Amendment Report for the Application of a Substantive Amendment to the Environmental Authorisation issued for the development of the 140 MW Sutherland 2 Wind Energy Facility, Sutherland, Northern Cape Province

DRAFT AMENDMENT REPORT

DEA Ref Number:
12/12/20/1782/3/AM3

October 2019

Figure 4: Changes in specifications of turbine dimension

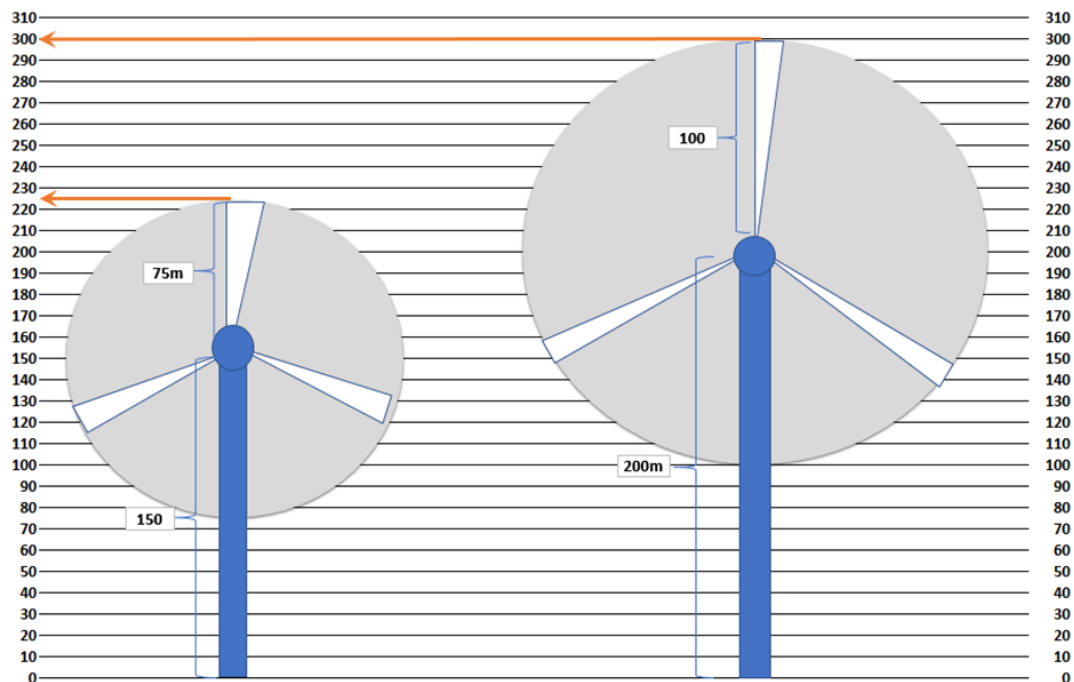
The main negative impact of turbines on bats is the encroachment of air space where bats forage or commute. Table 7 and Figure 4 indicate the increase in the volume of the total swept area, if turbine sweep is calculated as a sphere. For example, should 39 turbines be installed, with a hub height of 200 m and a rotor diameter of 200 m, there will be a 96.69 % increase in swept area. The lowest point of the sweep of the turbine blades is also indicated, as this could have an impact on bat mortality (see Literature review in Section 4.1 of the Bat specialist report (Moir & Dippenaar, 2019, included in Appendix C of this report).

Figure 6. Sutherland 2 WEF Viewshed: Amendment 2019: 200 m Hub Height (Oberholzer and Lawson, 2019).

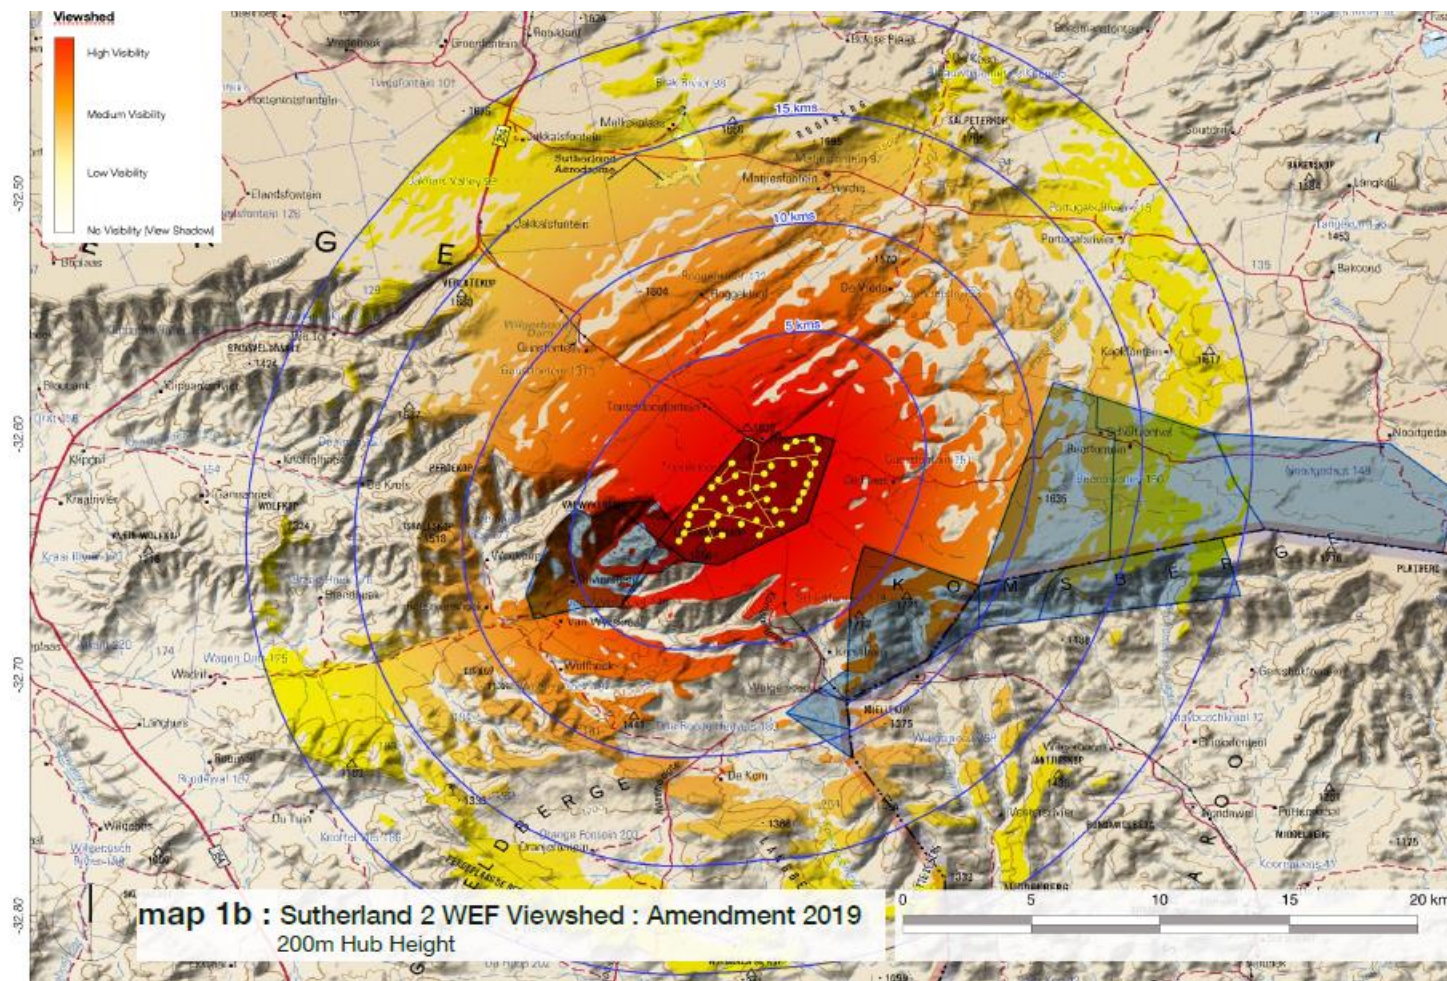
A revised viewshed for the larger turbines has been prepared to determine the visual exposure on the surrounding landscape and receptors, and whether there would be any increase in visual impact significance (see Figure 6). The current viewshed provides a useful comparison with the viewshed of the previous Amendment 2 layout, there being fairly minimal difference in visual exposure, the visual effect of which would decrease with distance. There would also be little or no further visual effect on the Komsberg escarpment scenic resource.

Figure 8. Combined WEFs (Rietrug, Sutherland, Sutherland 2) viewshed: Amendment 2019: 200 m Hub Height (Oberholzer and Lawson, 2019).

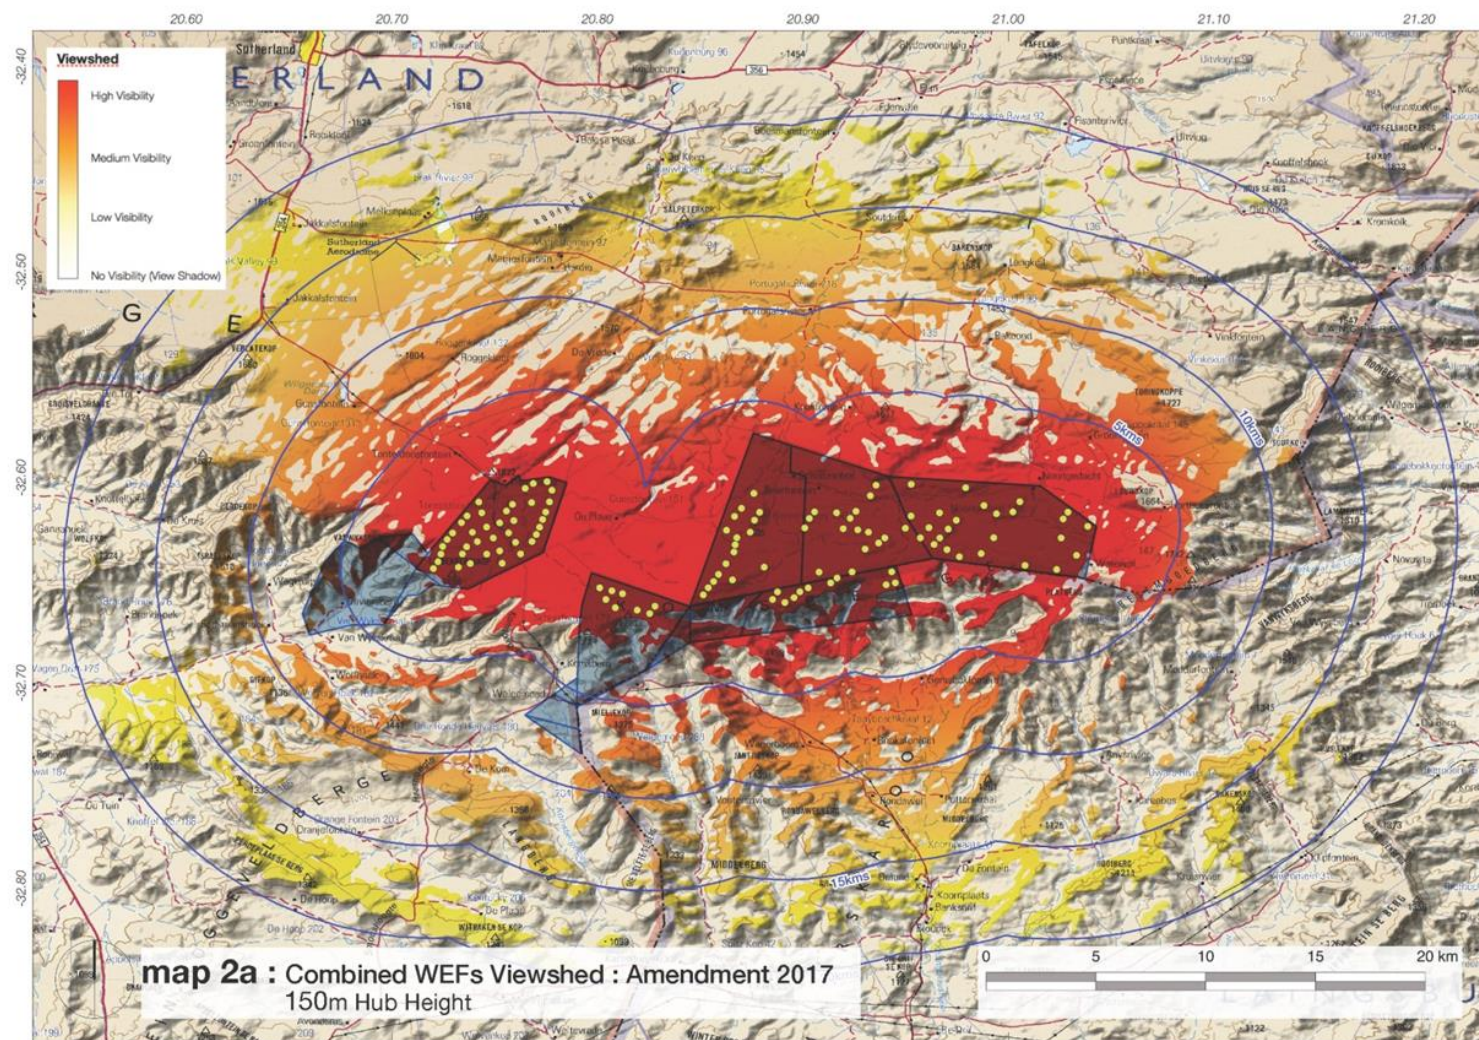
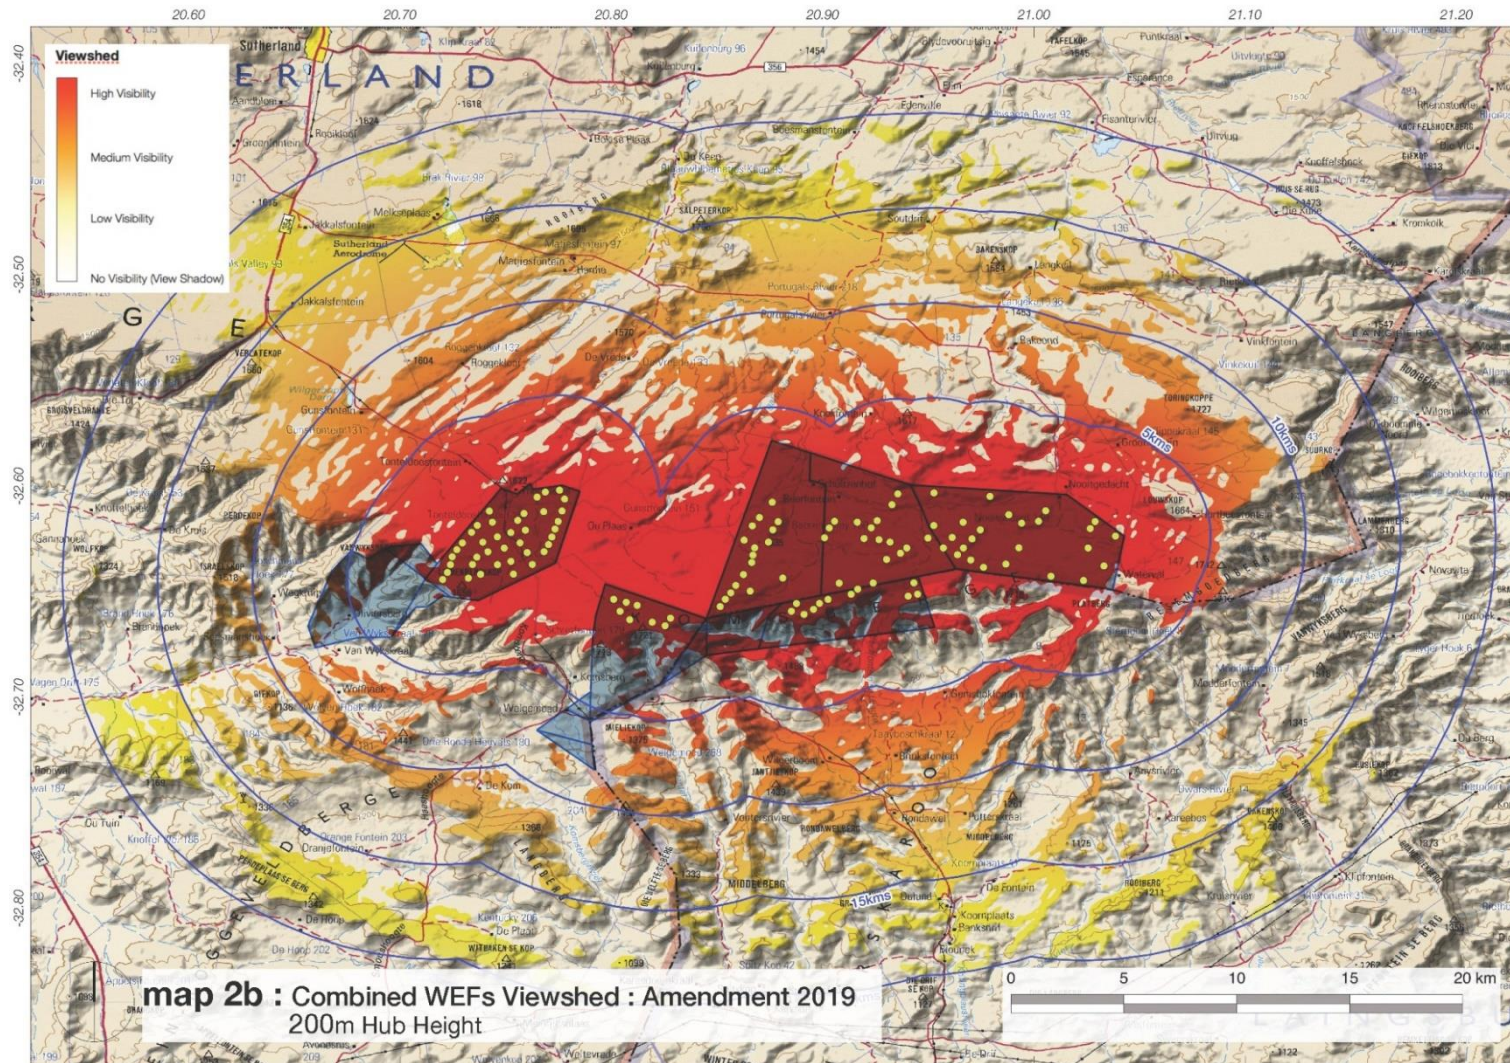
A comparison of the combined viewsheds of the 3 proposed wind farms for the Amendment 2 layout and the current layout is illustrated in Figures 7 and 8. The difference in visual exposure between these two is shown in Figure 8. Again, the cumulative difference in visual exposure is fairly minimal, but the visual

Figure 10: Authorised layout and amended layout of the Sutherland 2 Wind Energy Facility

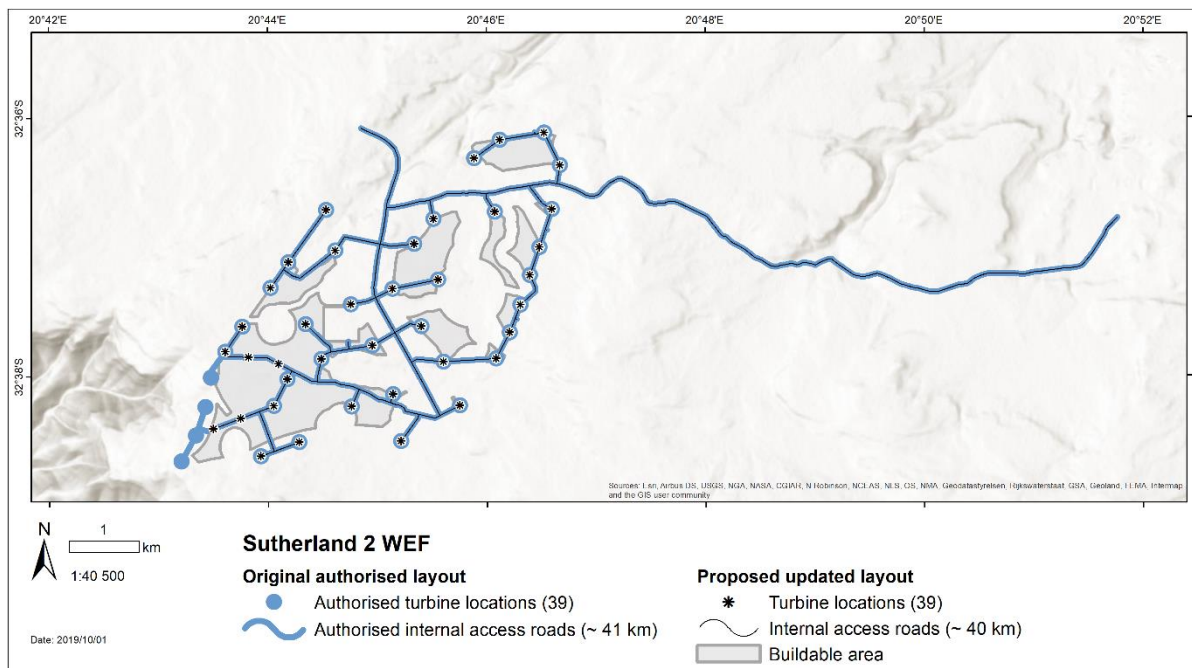
The turbine technology available for the authorised specifications, i.e. a 150 m hub height and 150 m rotor diameter, is no longer the preferred wind turbine technology since there are more efficient turbines available on the market (i.e. more megawatt output per turbine). Mainstream therefore wishes to amend the authorised turbine specifications **up to 200 m hub height and 200 m rotor diameter**, which is aligned with the preferred turbine technology currently available on the market. The increased wind turbine specifications have resulted in a decrease in the number of wind turbines required from 47 to **39**. This has resulted in a reduced turbine buildable area but the approved turbine layout will remain the same with the exception of four wind turbines. These wind turbines have been relocated within the remaining buildable area and the approved road layout plan.

Figure 12. Environmental sensitivity map overlay with the turbine locations for the Sutherland 2 WEF (with turbines numbered)

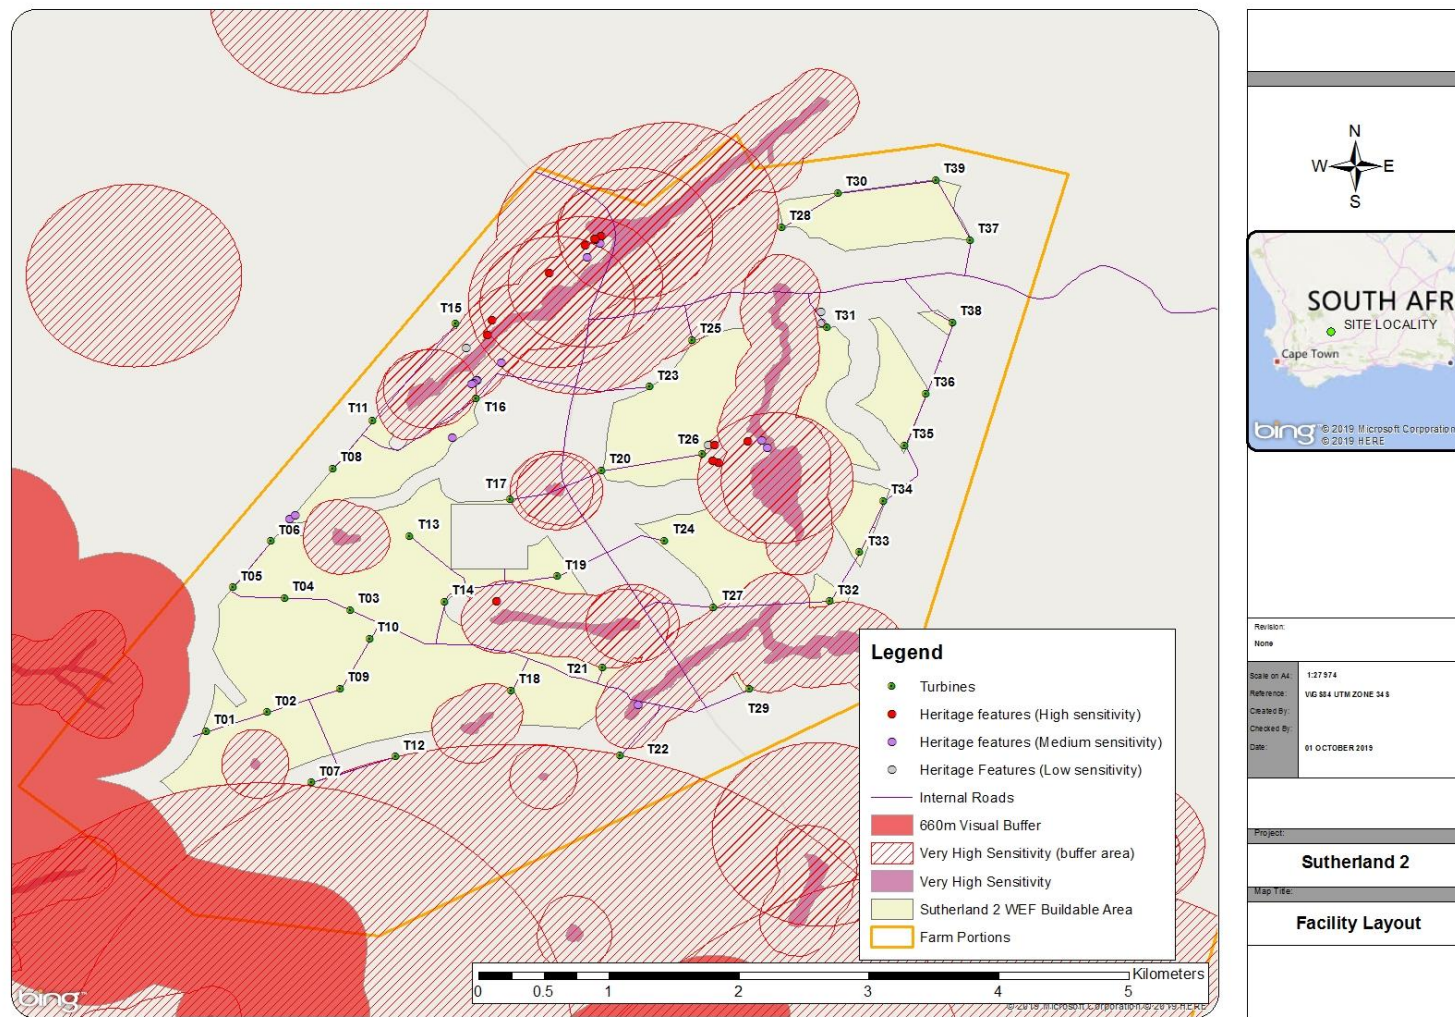
The proposed layout, which incorporates larger turbines, has been refined to include the buffer areas as provided by the specialists and has resulted in a reduced buildable area. The turbines however, avoid all environmental features that were identified on site, avoid areas that were recommended by the

specialists in the previous section and adhere to the provisions included within the Environmental Authorisation issued.
